# **PRELIMINARY HYDROLOGY FOR RENO CANNON INTERNATIONAL AIRPORT**

**NOVEMBER 19, 1992**

**RENO CANNON INTERNATIONAL AIRPORT  
RECONSTRUCT & EXTEND RUNWAY 16L-34R  
CONSTRUCT SERVICE ROAD & DRAINAGE**

**Preliminary Hydrologic Study  
From  
Thirty Percent Design Submittal**

**MODIFIED  
DRAINAGE AREAS**  
Job No. E0241.12  
**Exhibit 3.4 Greiner**

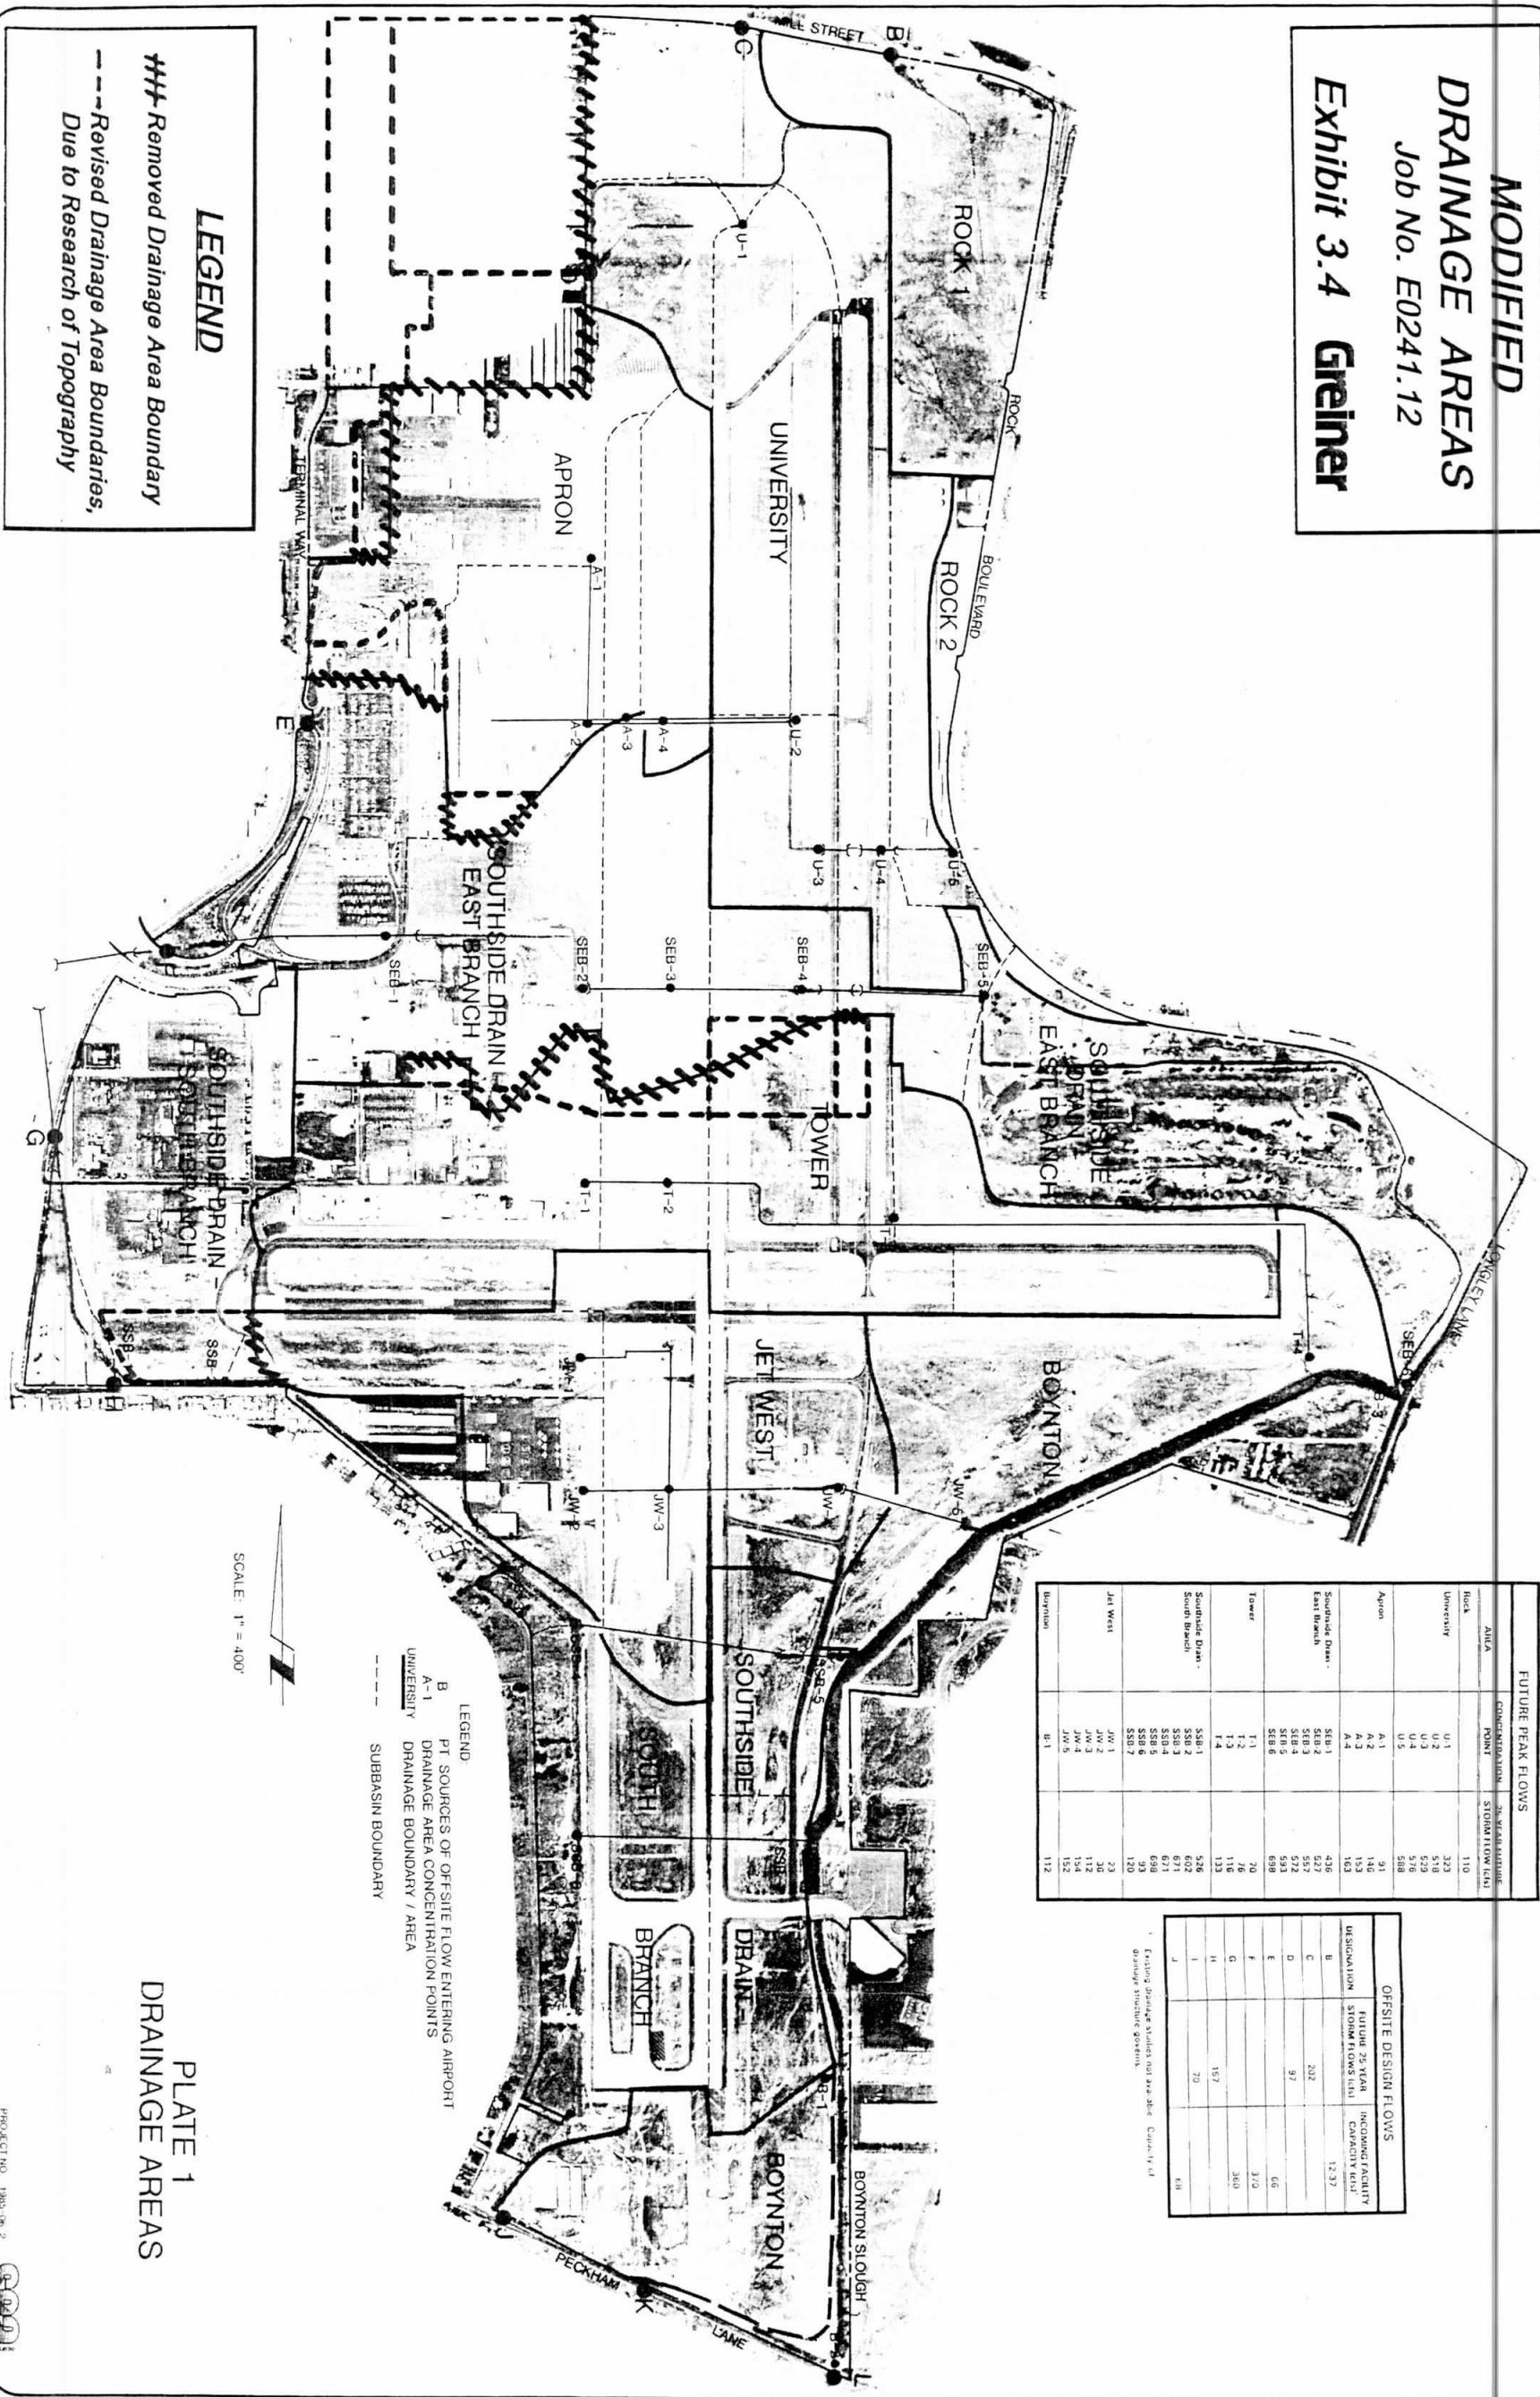
The pattern of flow within the infield area is based on the concept outlined within the Master Plan Drainage Study prepared by SEA, Inc. (see Exhibits 3.4 through 3.6 and Table 3.2). Significant points of departure are noted below and in Section 5.0 and described on Exhibit 3.4.

The infield system was analyzed in the Master Plan Drainage Study by SEA, Inc. (October 1992) by adding in the off-site 'capacity' flows for the Southside South Branch box culvert (under U.S. 395).

## Exhibit 3.5

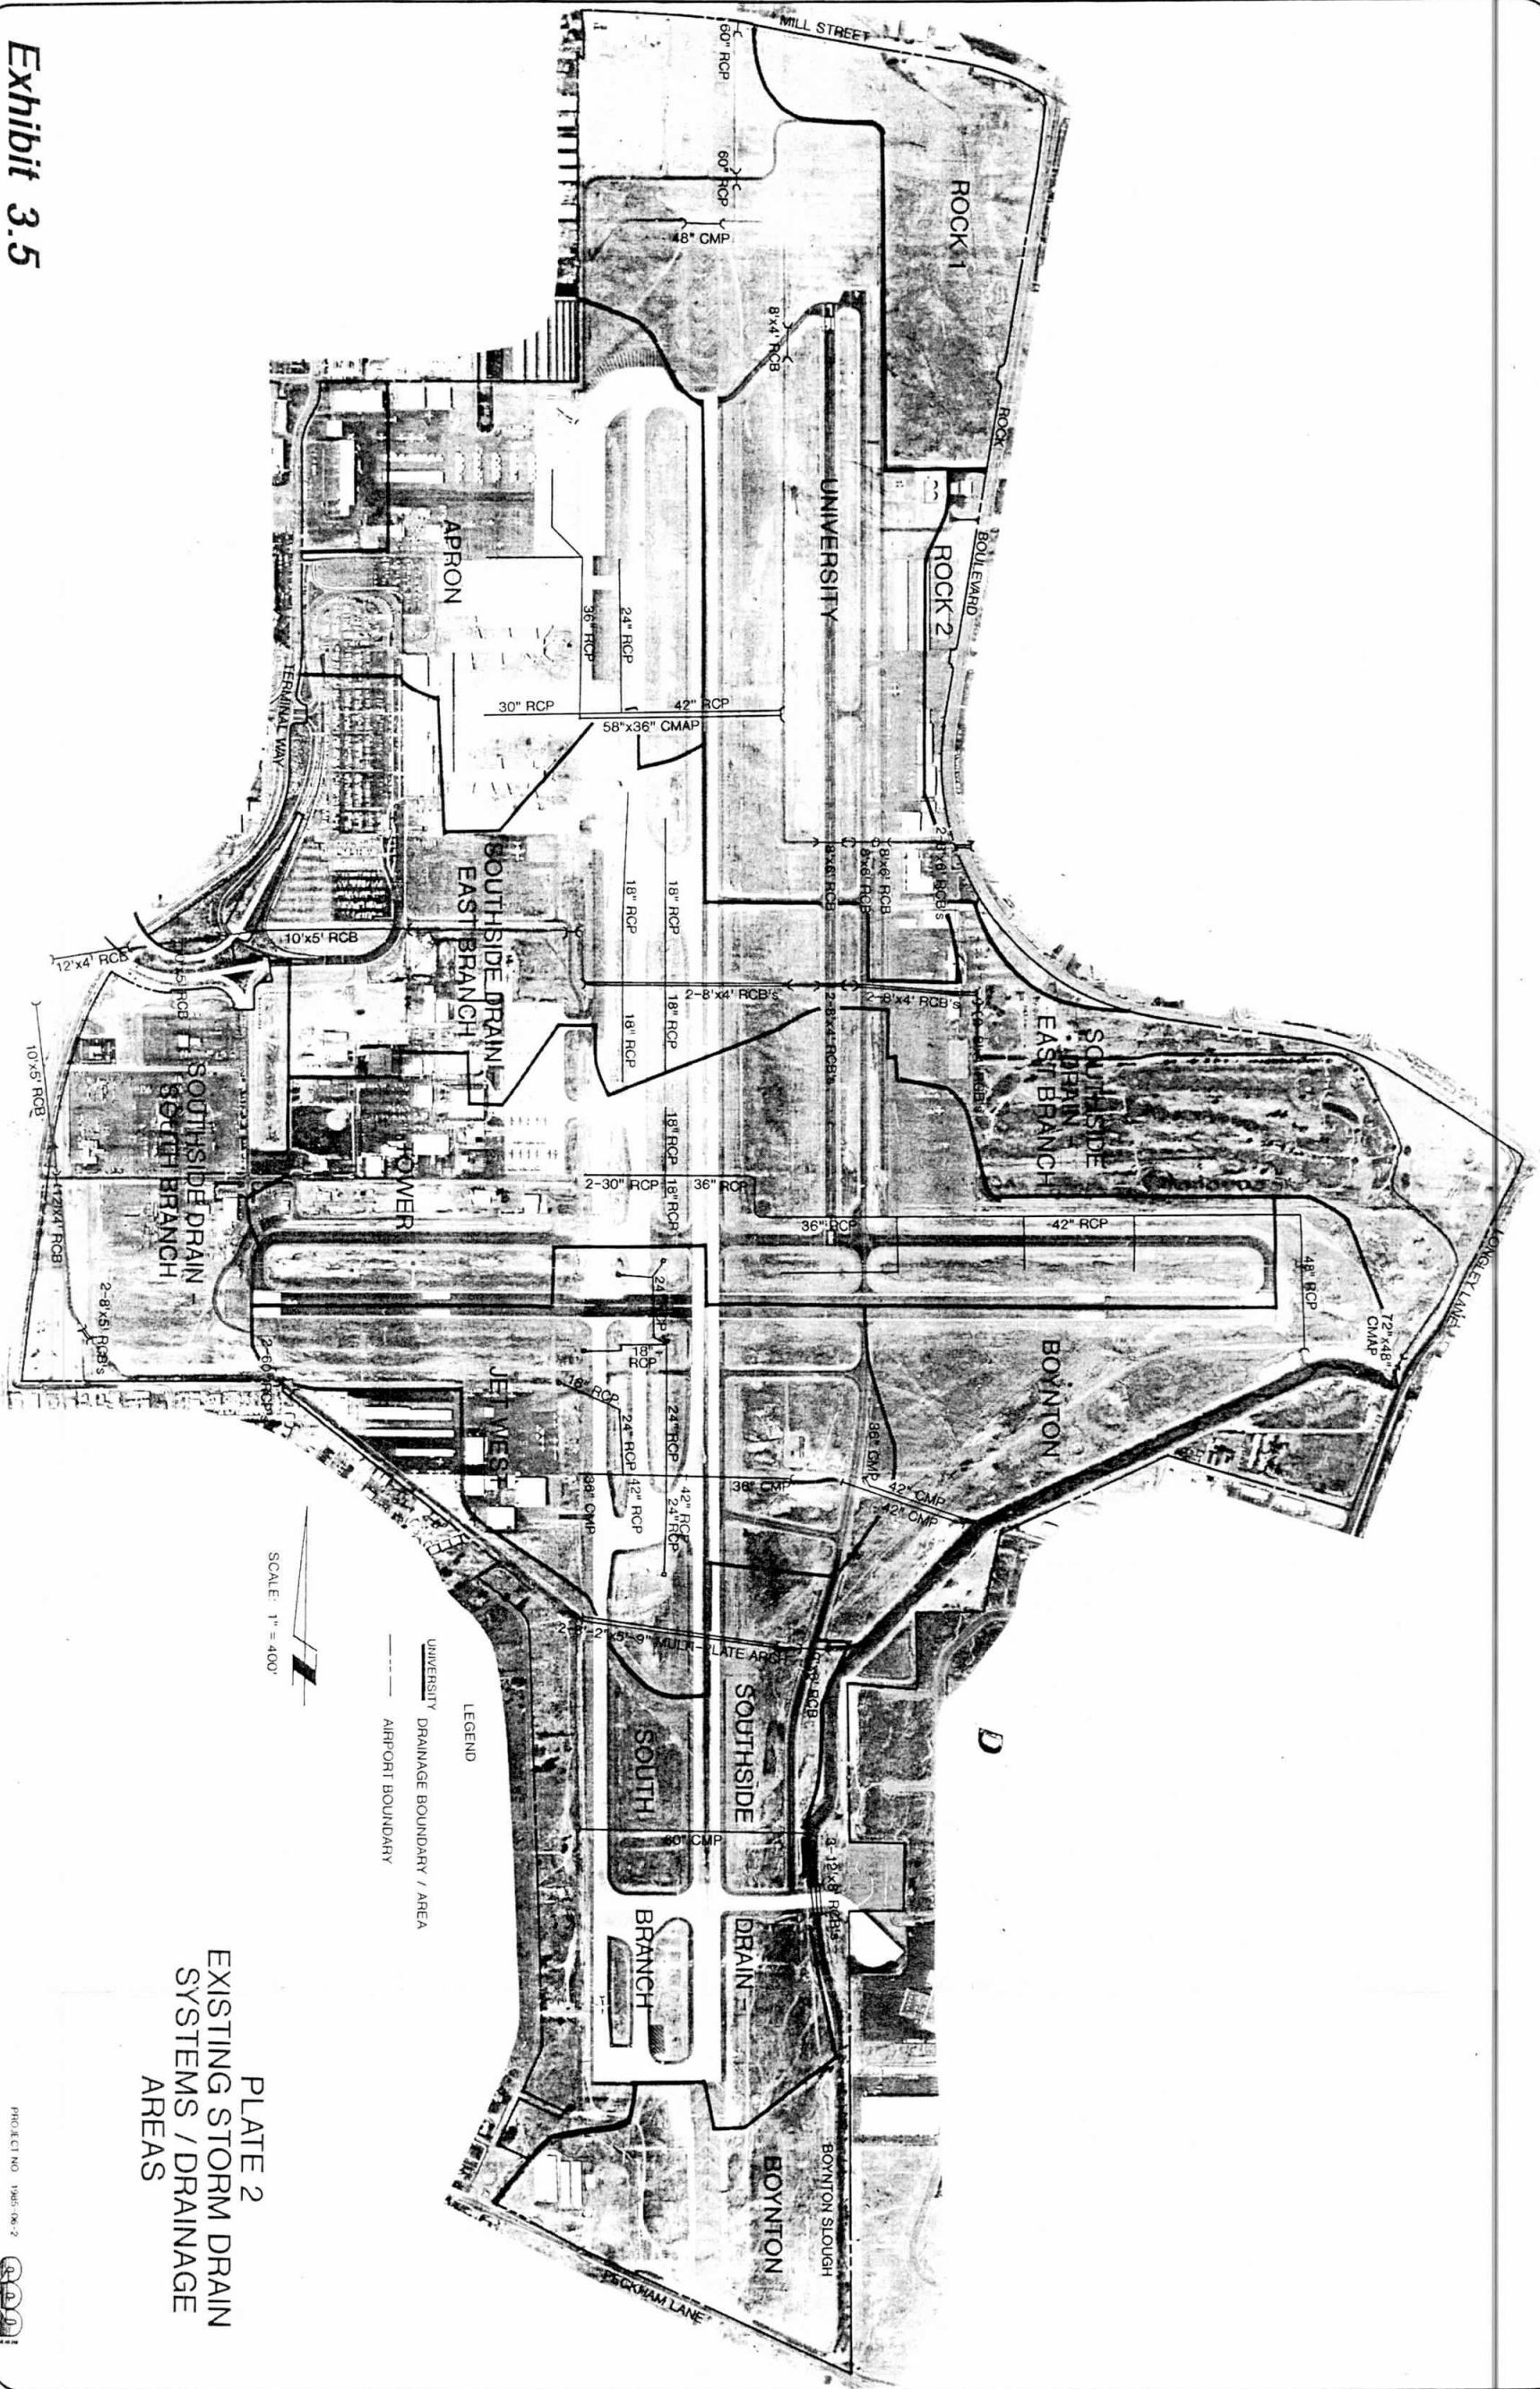
- ▶ Tailwater and target upstream headwater determination based on existing conditions
- ▶ Evaluation of the hydraulic design recommended in the Master Plan Drainage Study performed by SEA, Inc (refer to Exhibits 3.4 through 3.6).
- ▶ Analysis and design of alternative drainage systems
- ▶ Recommended hydraulic design
